**DESIGN REVIEW BOARD MEETING**

## DESIGN REVIEW BOARD

### *Staff Report*

<b>PROJECT NAME</b>
Estero Crossing Commercial Development, Pocket Park/Entry Area
<b>CASE NUMBER</b>
DOS2020-E007
<b>MEETING DATE</b>
March 10, 2021
<b>REQUEST</b>
Application to develop the commercial part of this project along with monument signs.
<b>APPLICANT</b>
Keith Gelder, SD Estero Crossing, LLC
<b>LOCATION</b>
10500 Corkscrew Road, Estero, FL 33928, on the south side of Corkscrew and east side of Lowe’s Plaza
<b>PROPERTY SIZE</b>
42.97 acres (Total Project)
<b>ZONING</b>
Parcel was rezoned from the Commercial Planned Development District (CPD) to Mixed Use Planned Development District (MPD) (Case number DCI2015-00001) 10/16/2019
<b>PUBLIC INFORMATION MEETING DATES</b>
The most recent DRB Public Information Meeting was held on August 26, 2020. Development Order application was submitted on 7/14/2020 (DOS2020-E007)

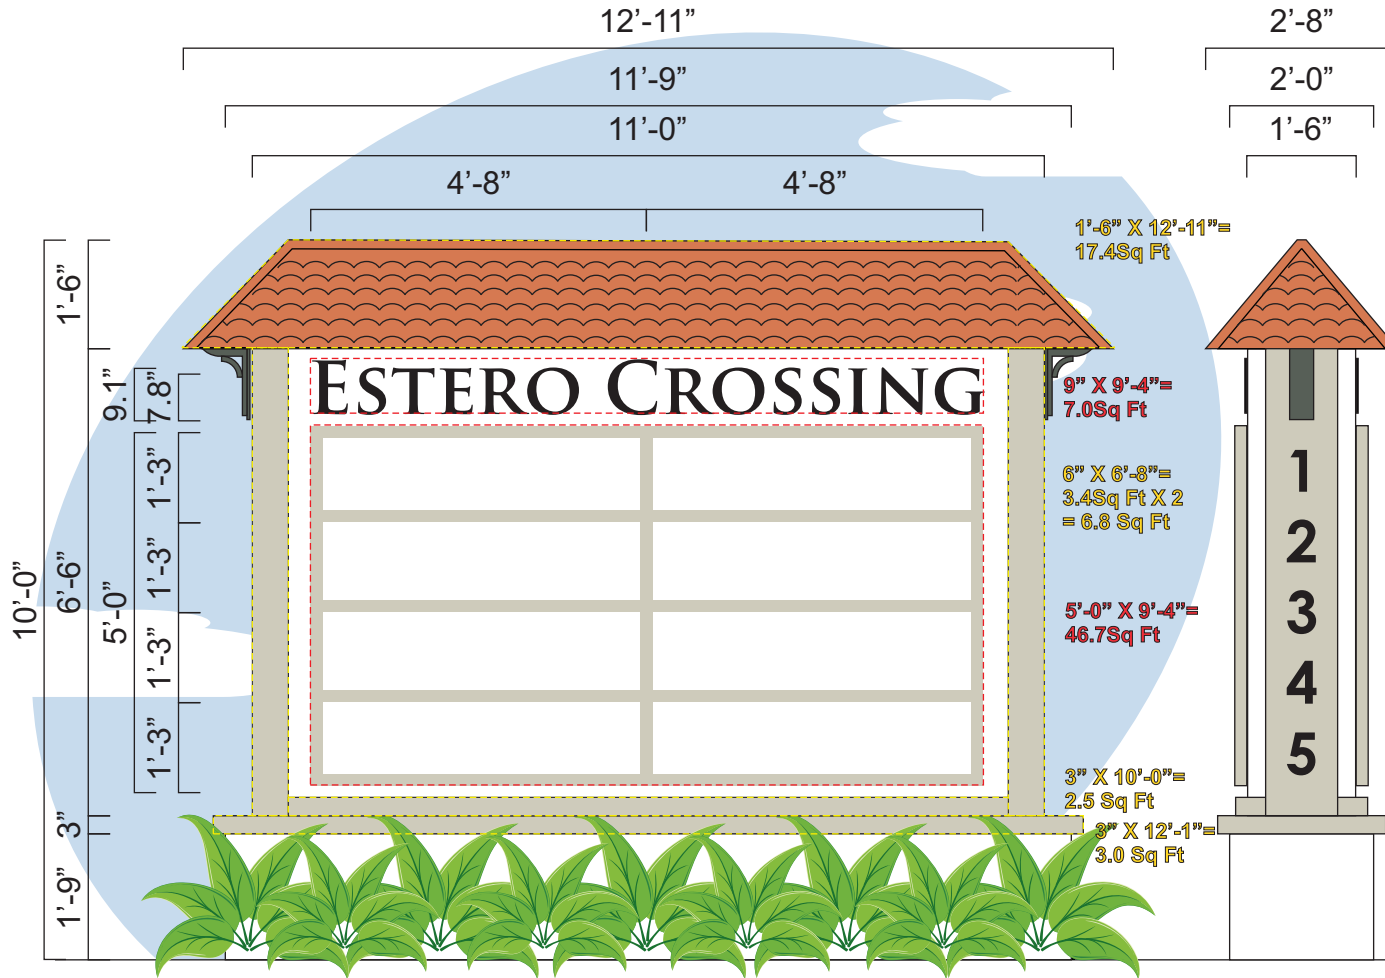
- Public Art: DRB will need to review the Public Art: ***MGA Sculpture Studio in St. Petersburg, Florida has been engaged for the Public Art Feature. It's understood a separate DRB meeting to review this feature may be necessary. The Artwork will be installed prior to CC. The intention is to present initial renderings to the DRB in a Workshop as soon as available.***

**MANUFACTURE & INSTALL ONE (1) DOUBLE FACED, ILLUMINATED GROUND SIGN.**

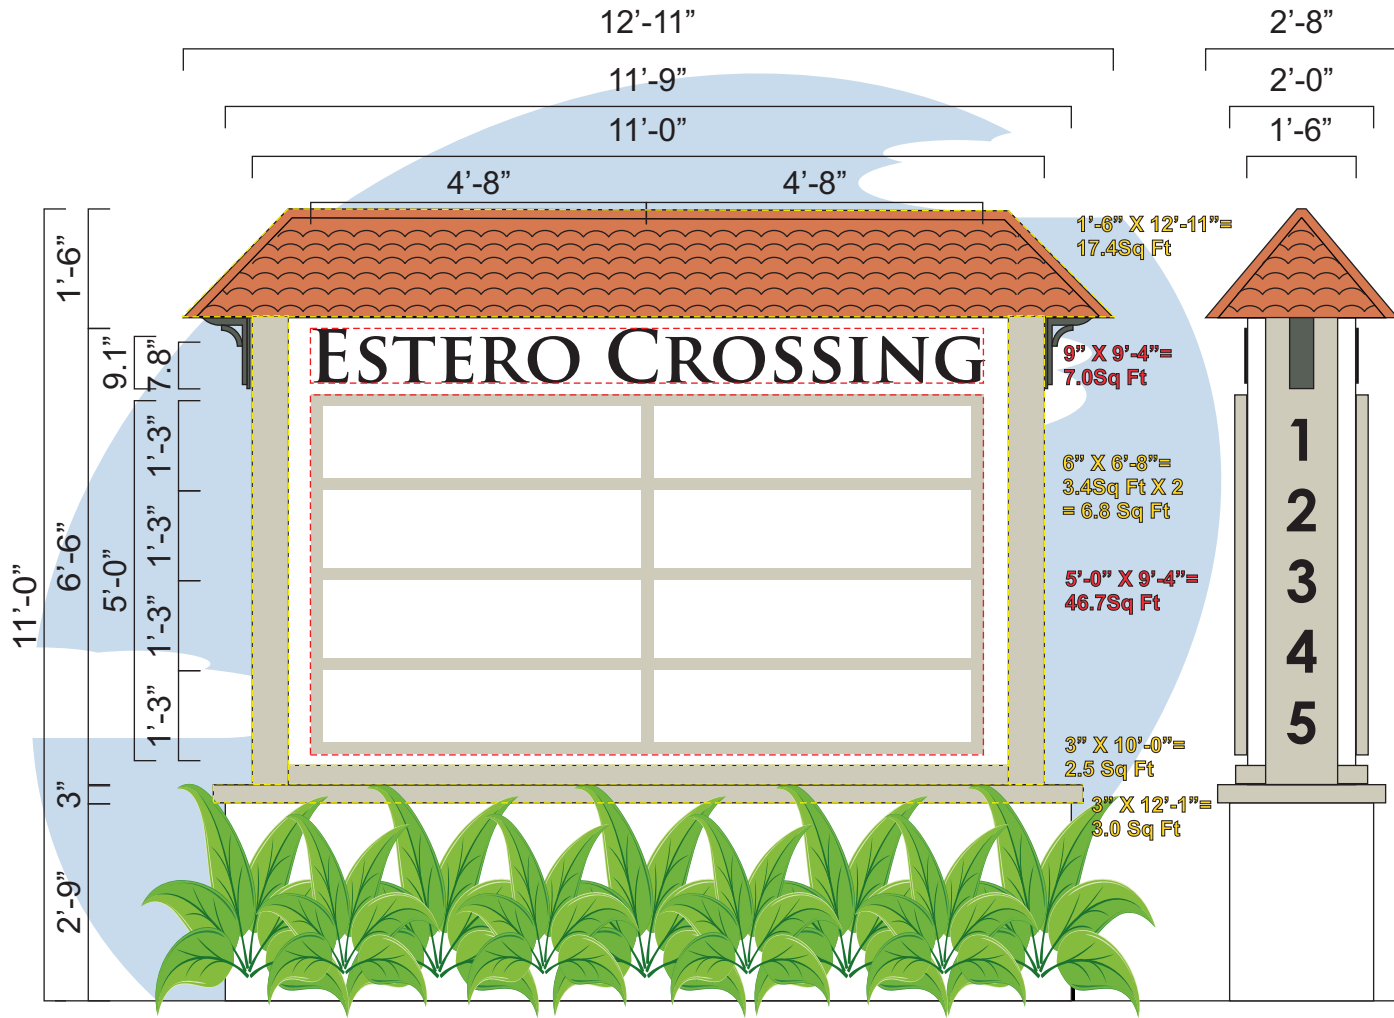
- Base: If plantings hide sign base, the hidden base area cannot be used to satisfy the architectural area requirement: ***The sign bases have been raised slightly so the top cap of the base is above the adjacent landscape material. The area below is excluded from the sign area. The ends of the sign have been revised to add additional architectural detail.***
